**ADDENDUM NO. 3  
TO PLANS AND SPECIFICATIONS FOR THE  
ALPENA WATER PRODUCTION PLANT (WPP) CLEARWELL REPLACEMENT  
& INFRASTRUCTURE IMPROVEMENTS**

**ISSUED:** March 13, 2024

HRC Job No. 20220751

ADDENDUM NO. 3 - 3/13/24  
ALPENA WPP - OVERFLOW  
LOCATION SKETCH FROM  
OWNER'S FILES

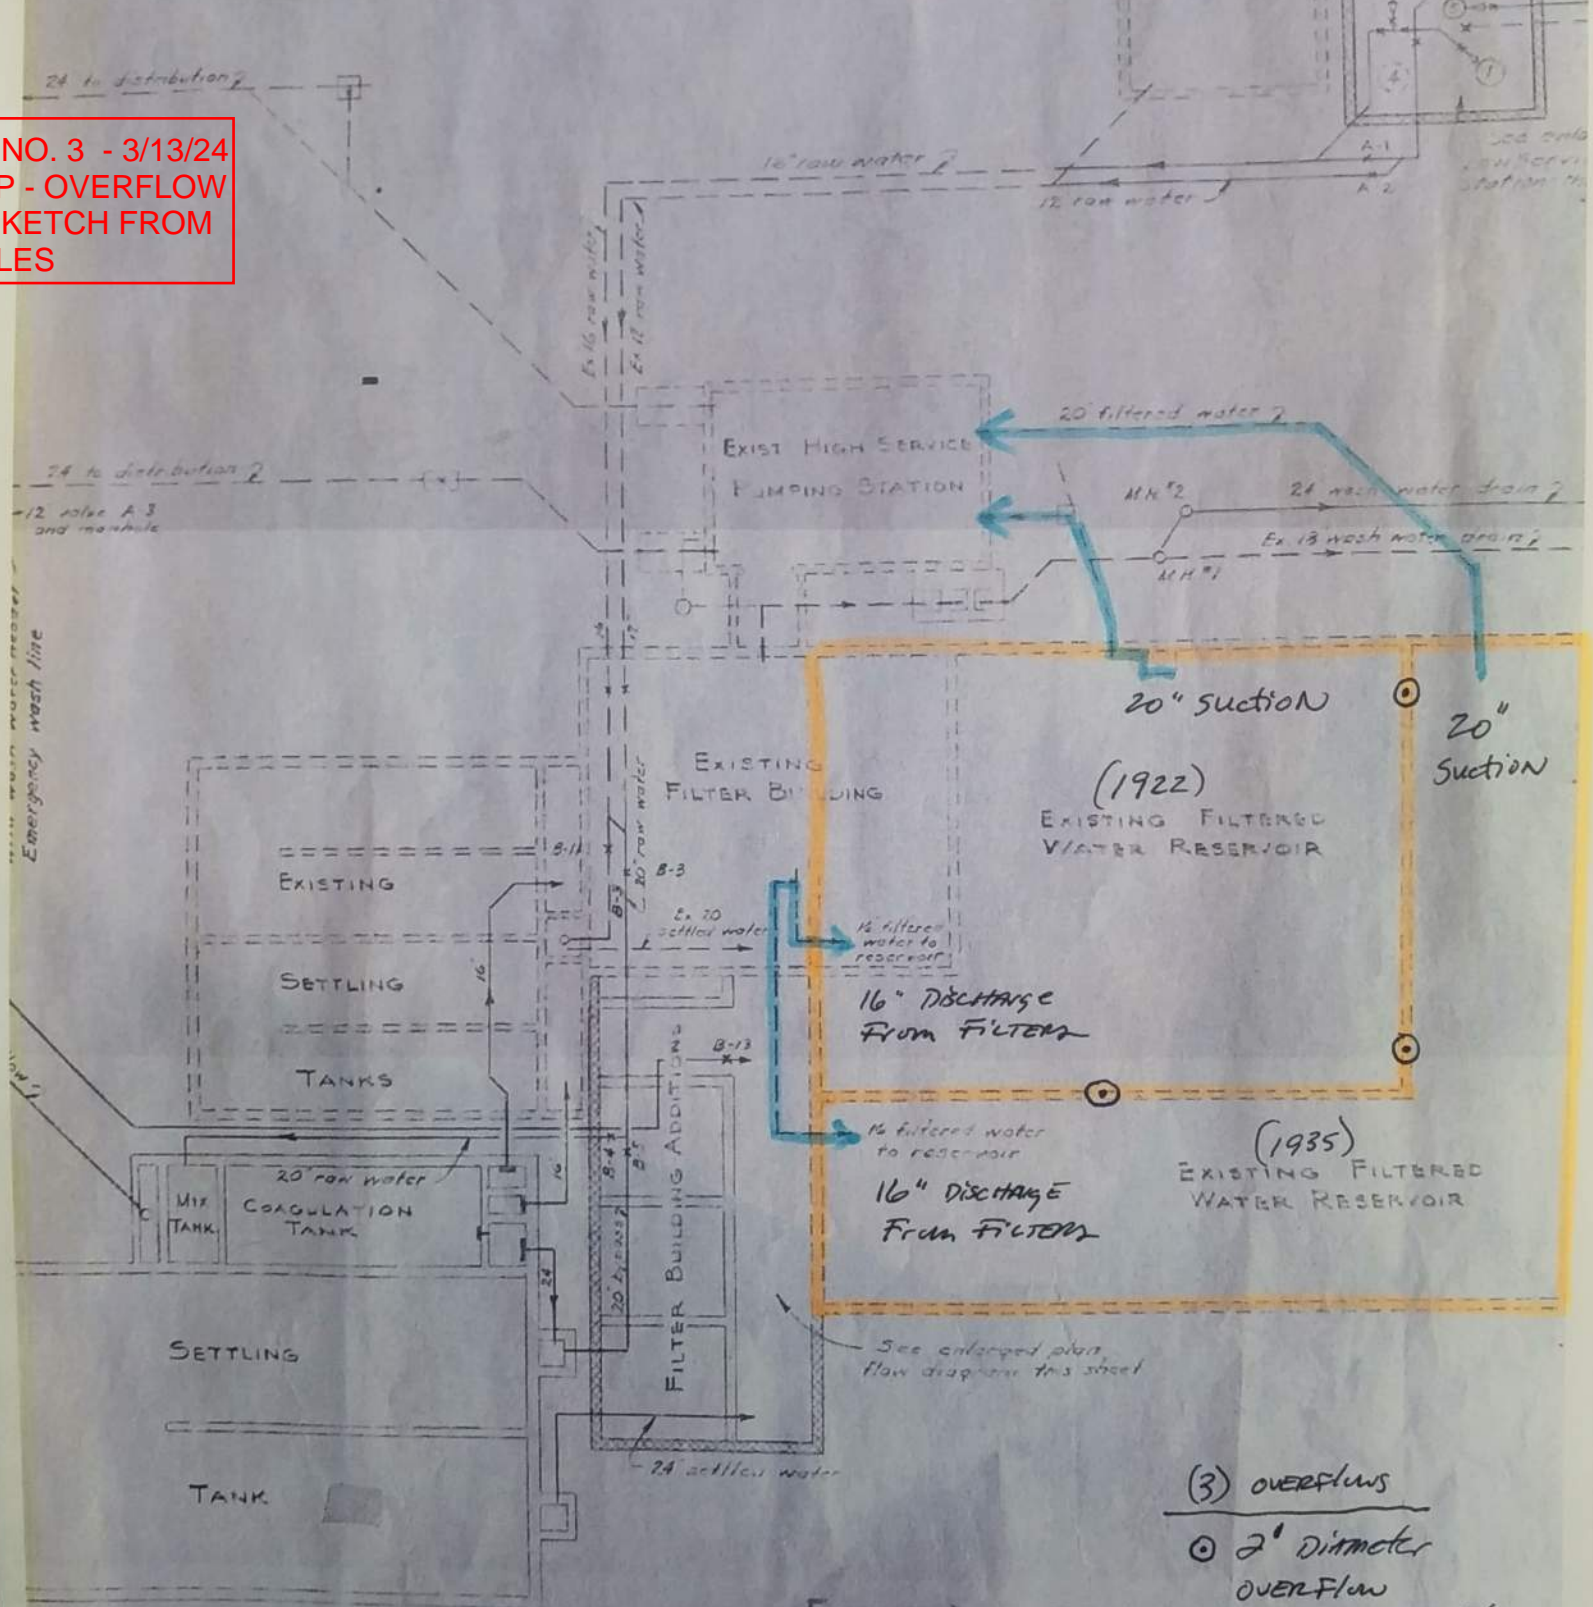
- II. The only information available regarding the size and location of the (3) overflow holes in the common wall between Cell 1 and Cell 2 is shown on the attached sketch that was provided from the Owner's files. This information has not been field verified but, the holes were described as approximately 2 ft in diameter, 9 ft above the tank floor.

- (3) OVERFLOWS
- 2" DIAMETER OVERFLOW ABOUT 9' FROM FLOOR

**PROPOSED CLEARWELL SECTIONS**

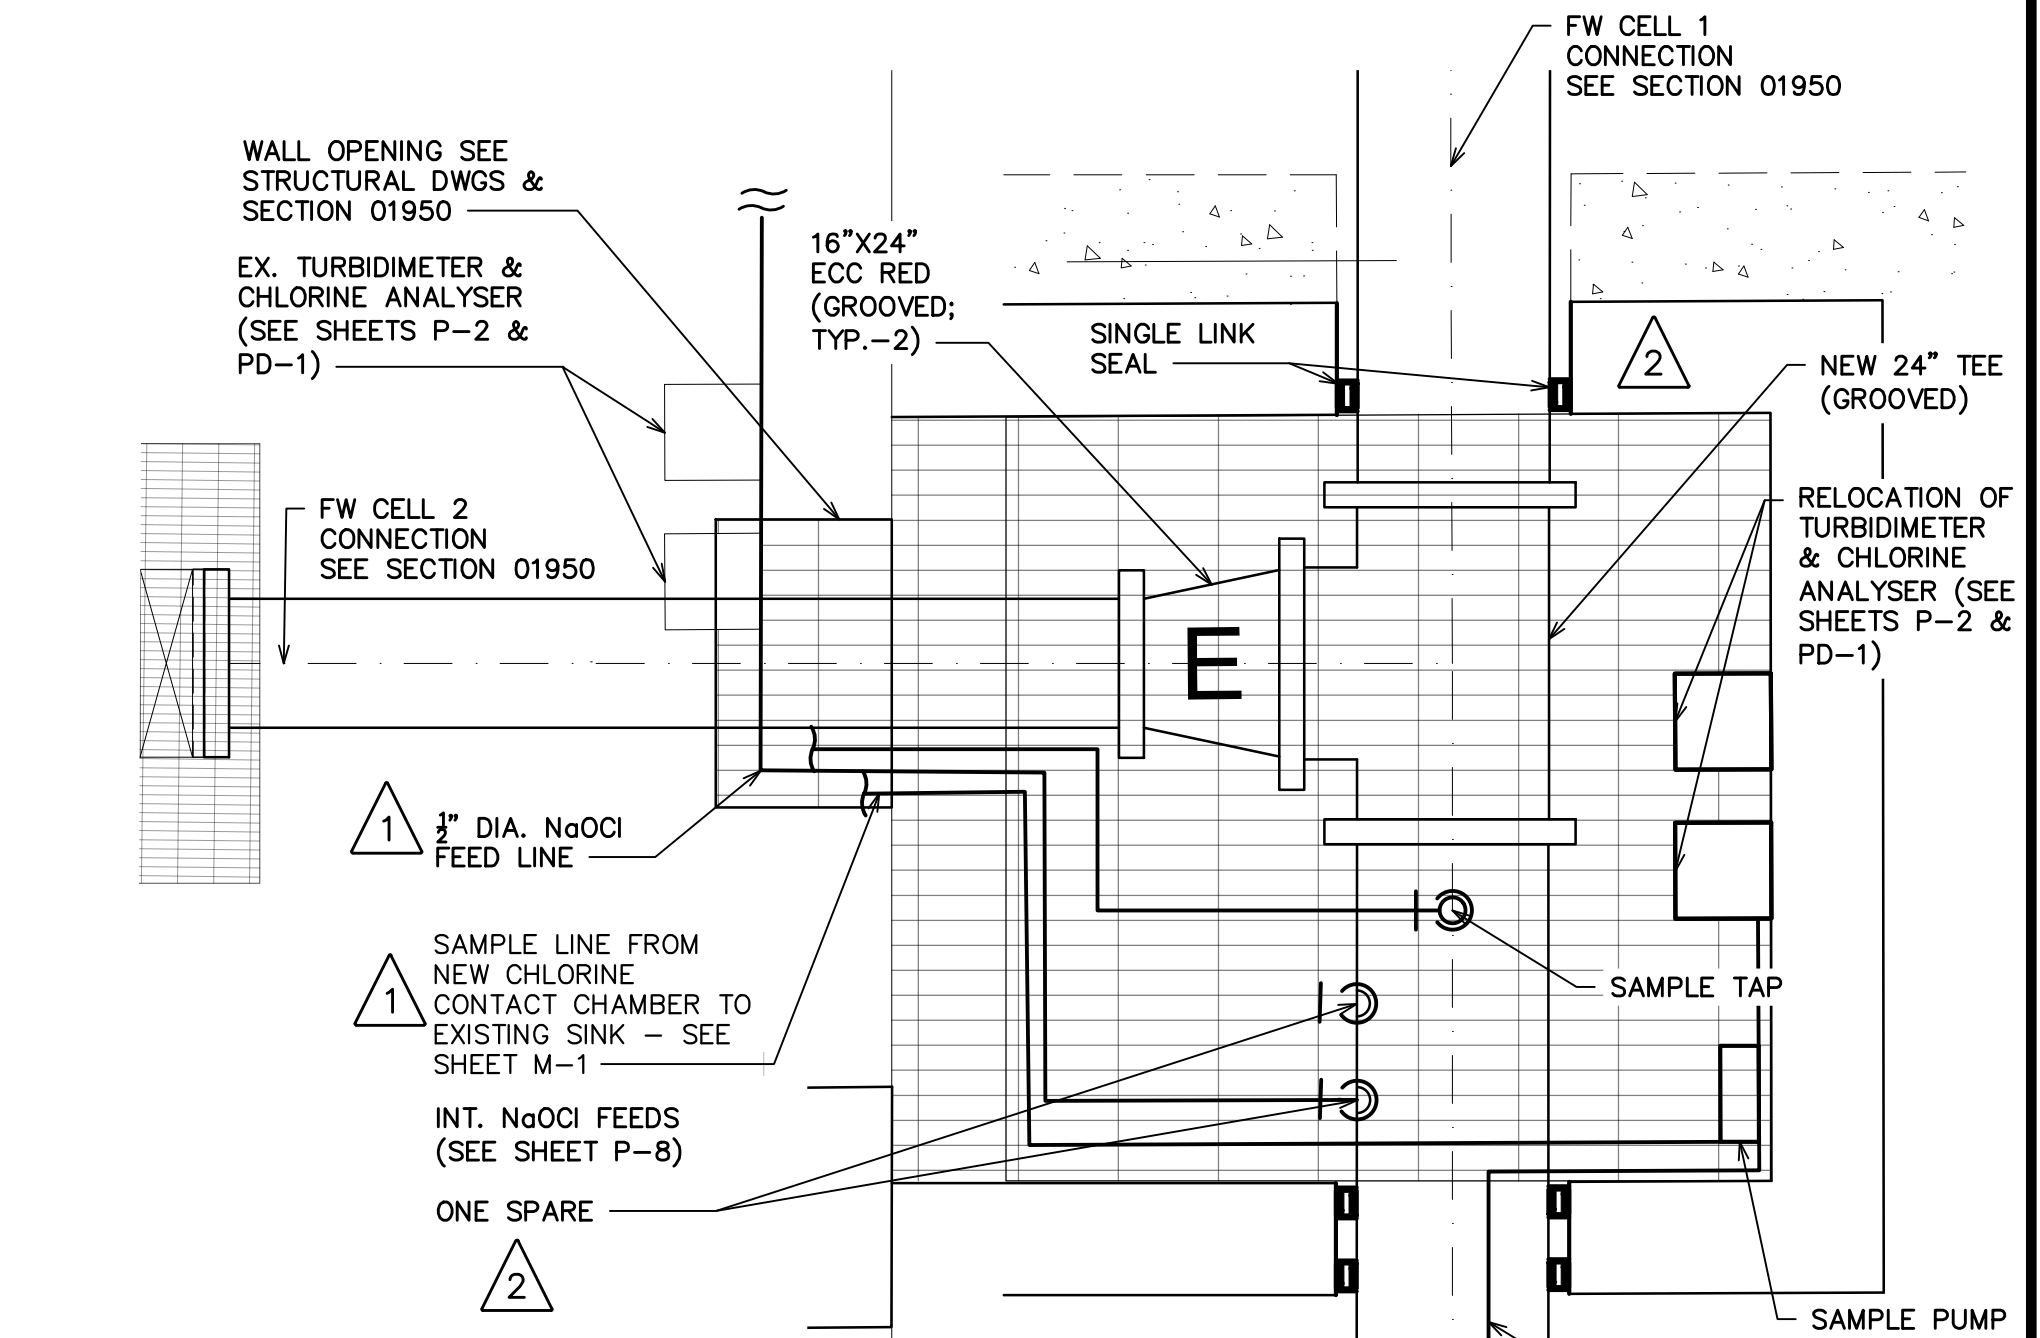
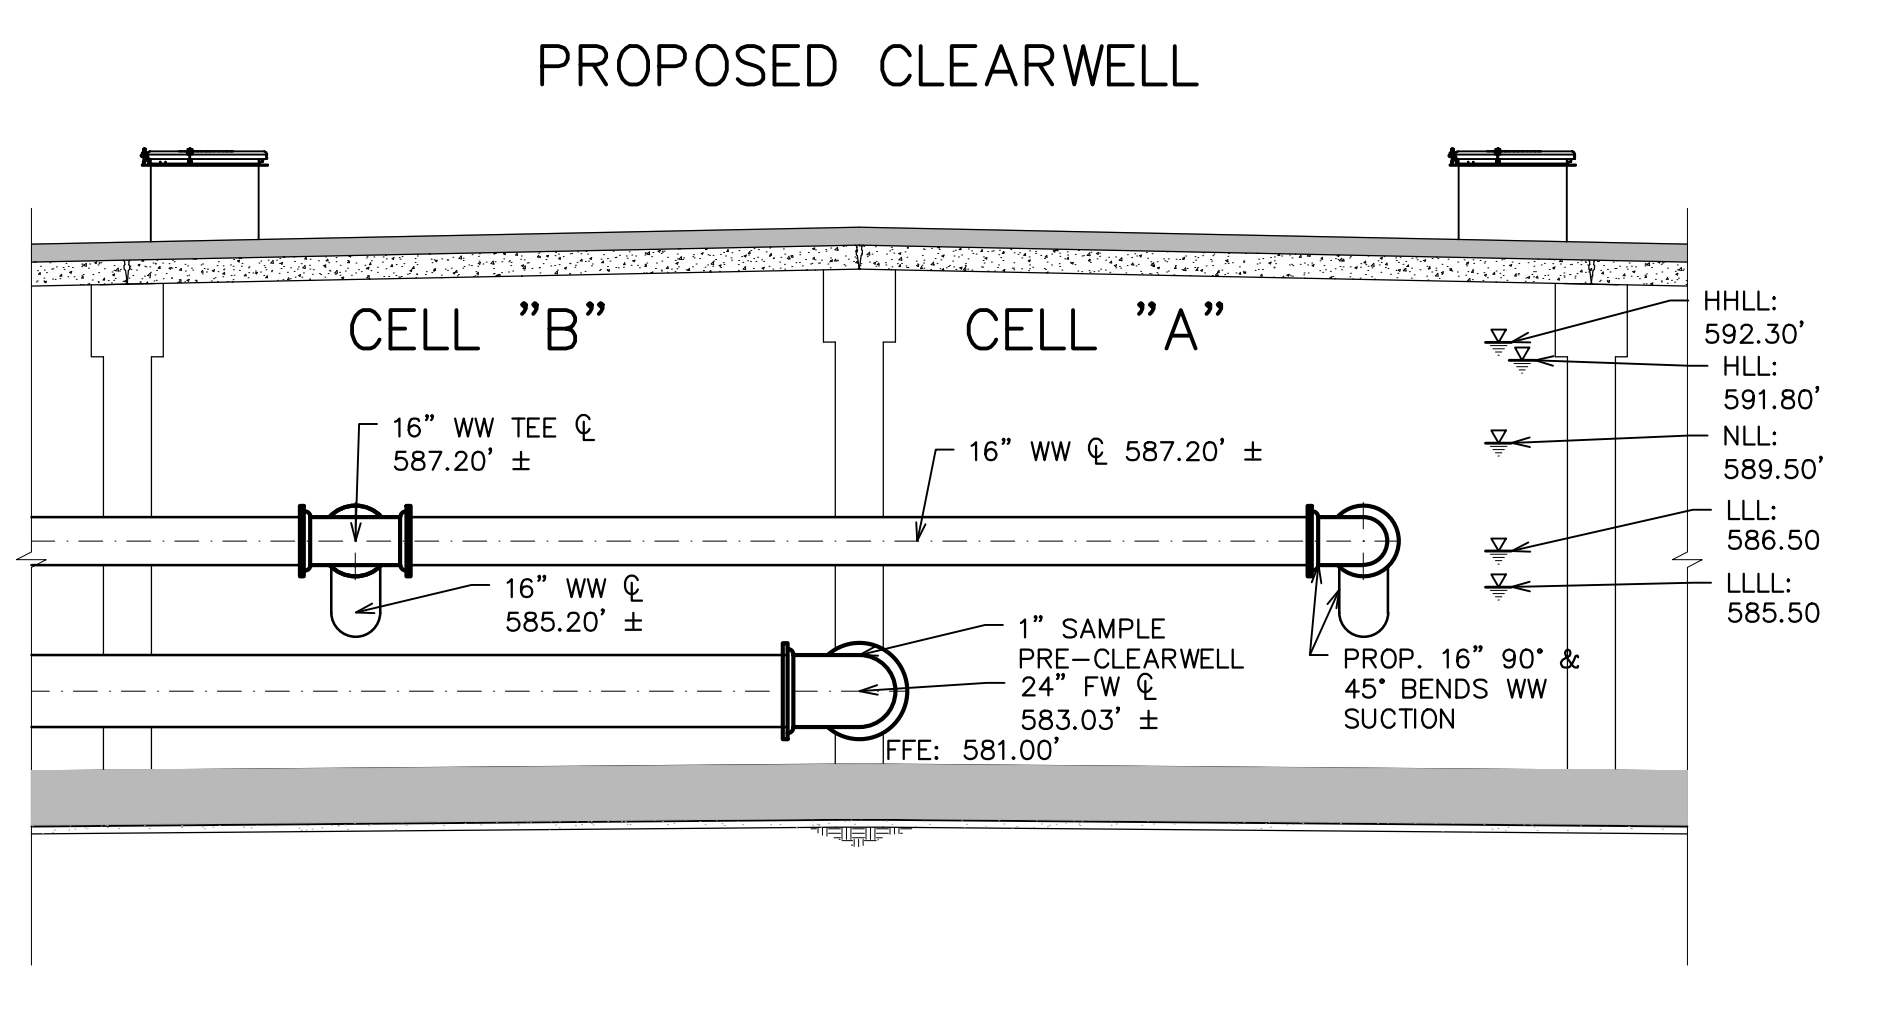
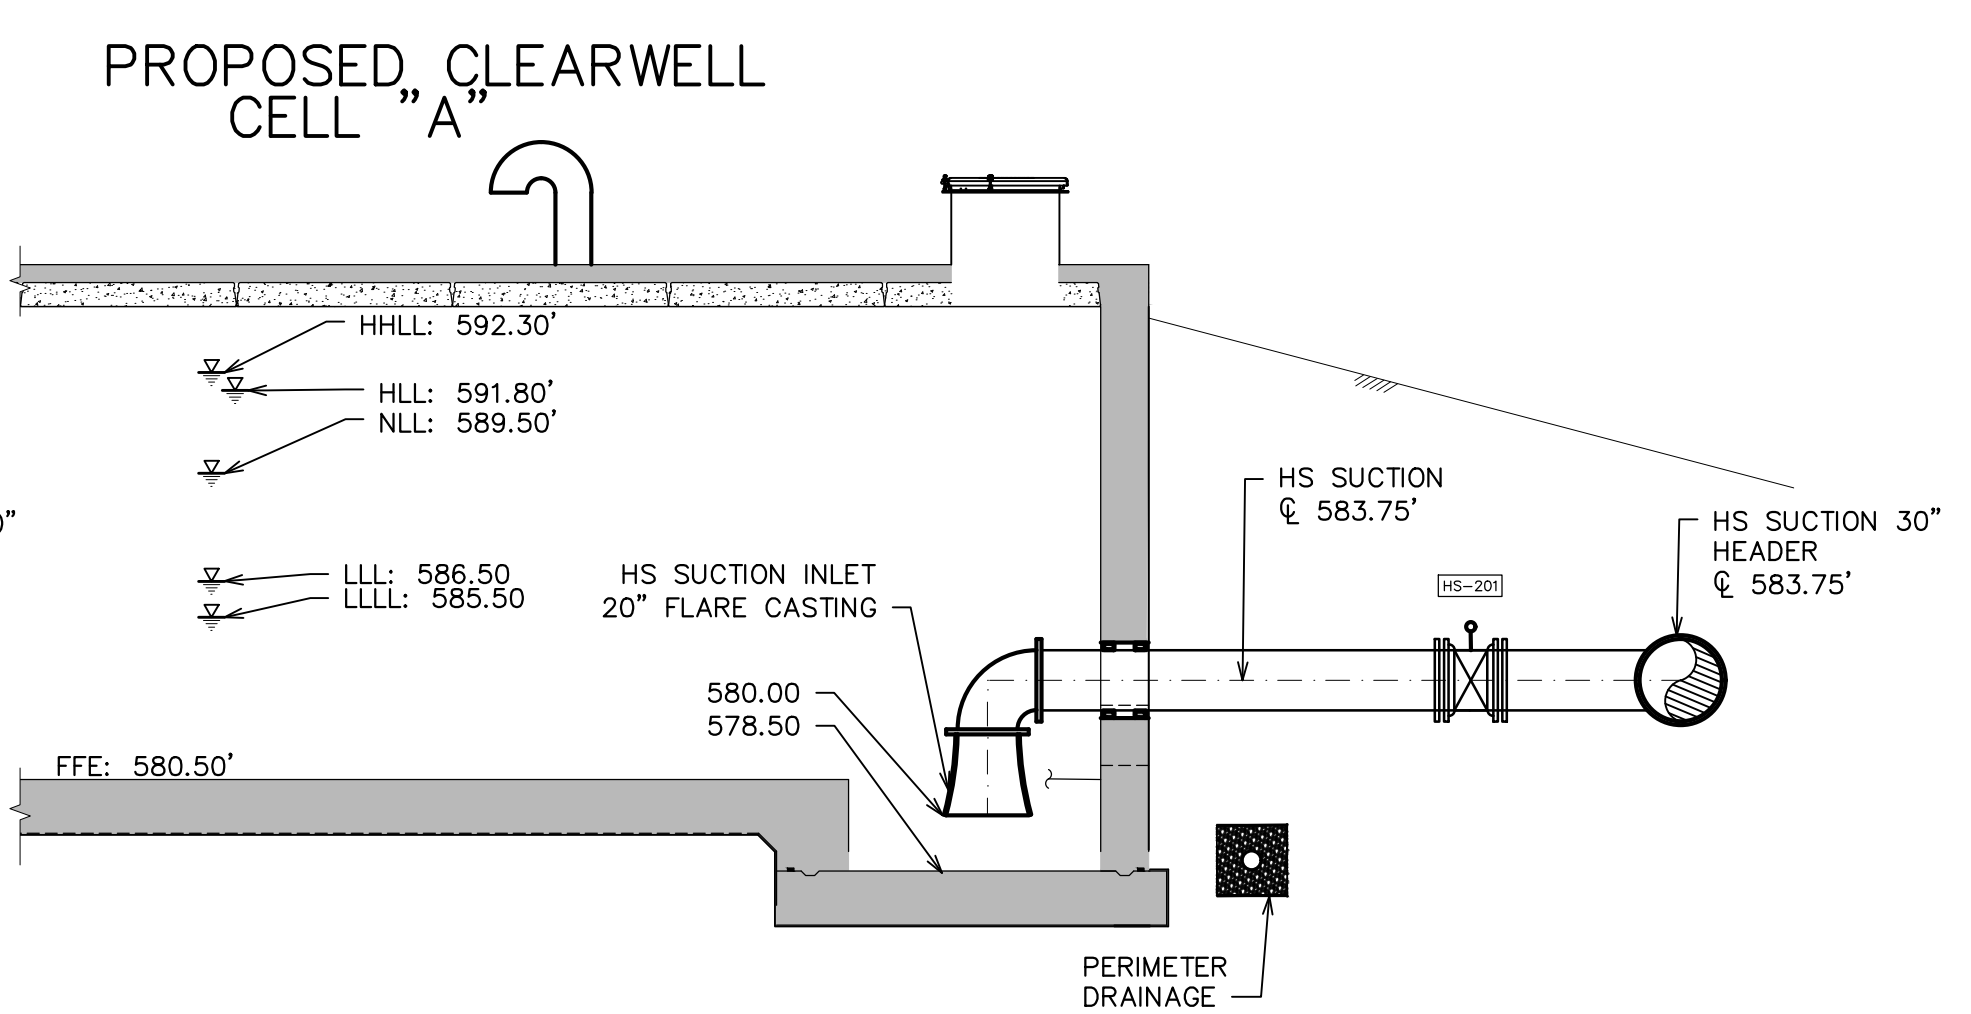
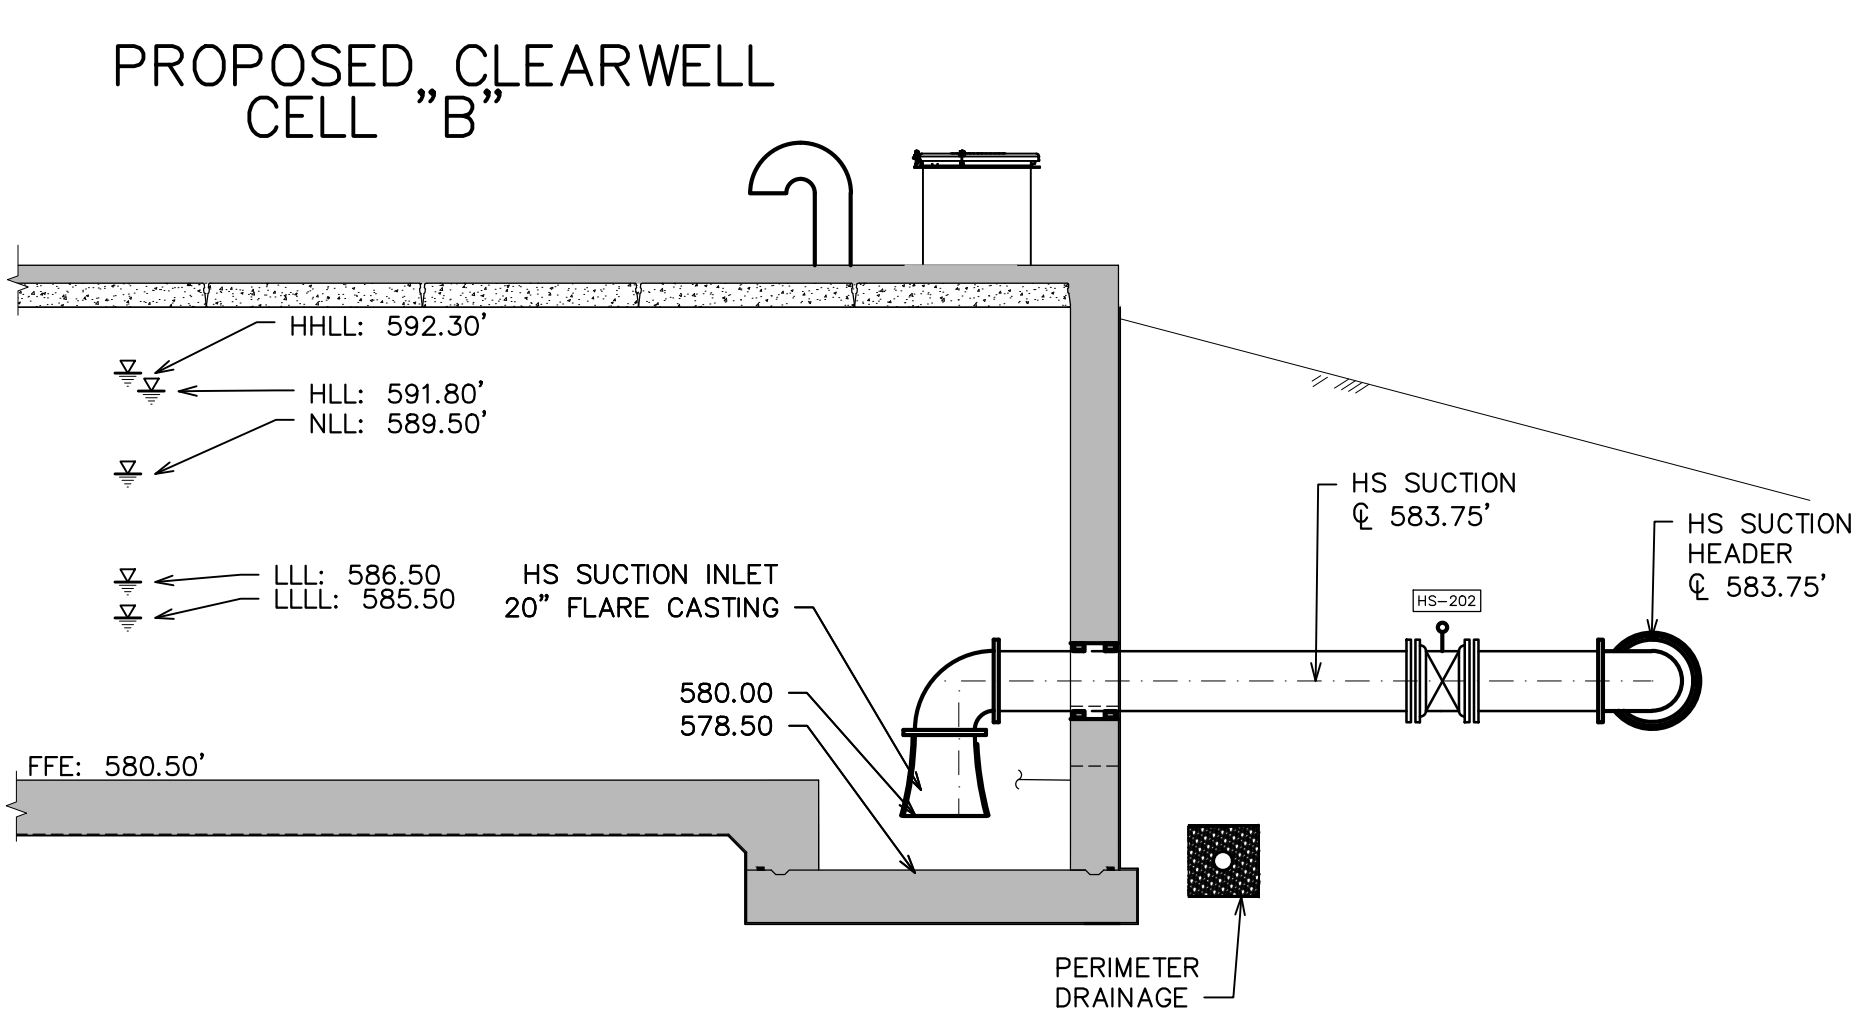
1. SHEET P-5 (Issued) – See updated sheet.
2. SHEET P-9 (Issued) – See updated sheet.
